PCN #: 2540

PCN Title: Qualified Additional Fab Site, Assembly/Test (A/T) Sites, Bill of Material (BOM) and updated Device Data Sheets

PRODUCT CHANGE NOTICE

PCN-2540 REV 1

PI7C9X113SL

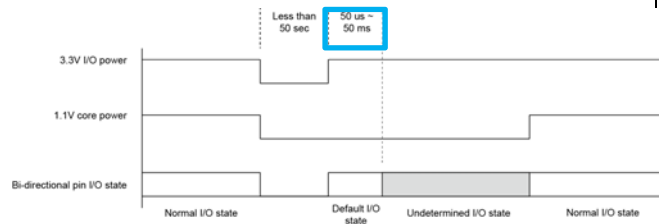
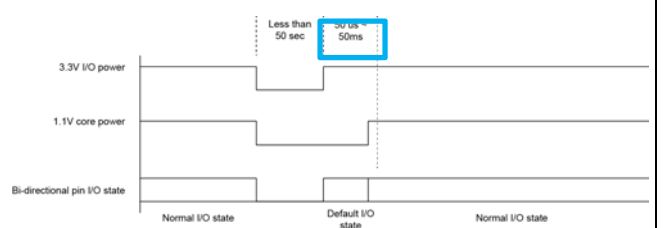
When 1.1V core power is applied after 3.3V IO power is applied, there might be glitch at reset pins (PERST_L and RESET_L), and an external RC filter can be used to filter out the glitch if necessary.

If the gap between 3.3V IO power and 1.1V core power is too big, there might be glitch at pin RESET_L. The maximum gap is recommended to be 50us~50ms, customer needs to measure the waveform of RESET_L to make sure there is no glitch during the gap.

PI7C9X118SL

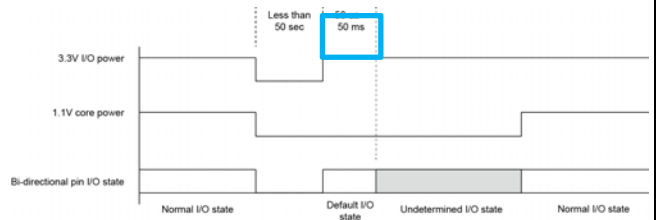
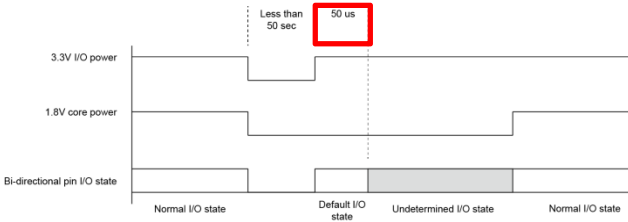
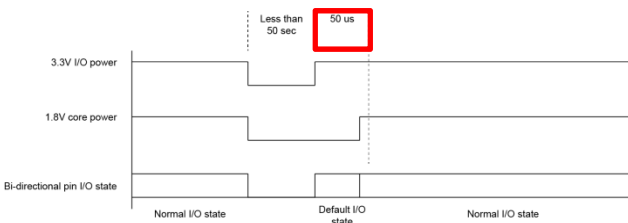
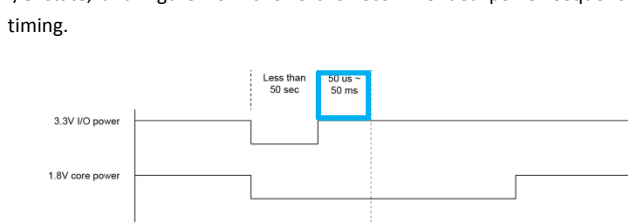
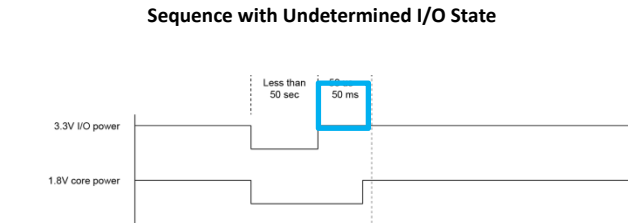
When 1.1V core power is applied after 3.3V IO power is applied, there might be glitch at reset pins (PERST_L and RESET_L), and an external RC filter can be used to filter out the glitch if necessary.

If the gap between 3.3V IO power and 1.1V core power is too big, there might be glitch at pin RESET_L. The maximum gap is recommended to be 50us~50ms, customer needs to measure the waveform of RESET_L to make sure there is no glitch during the gap.
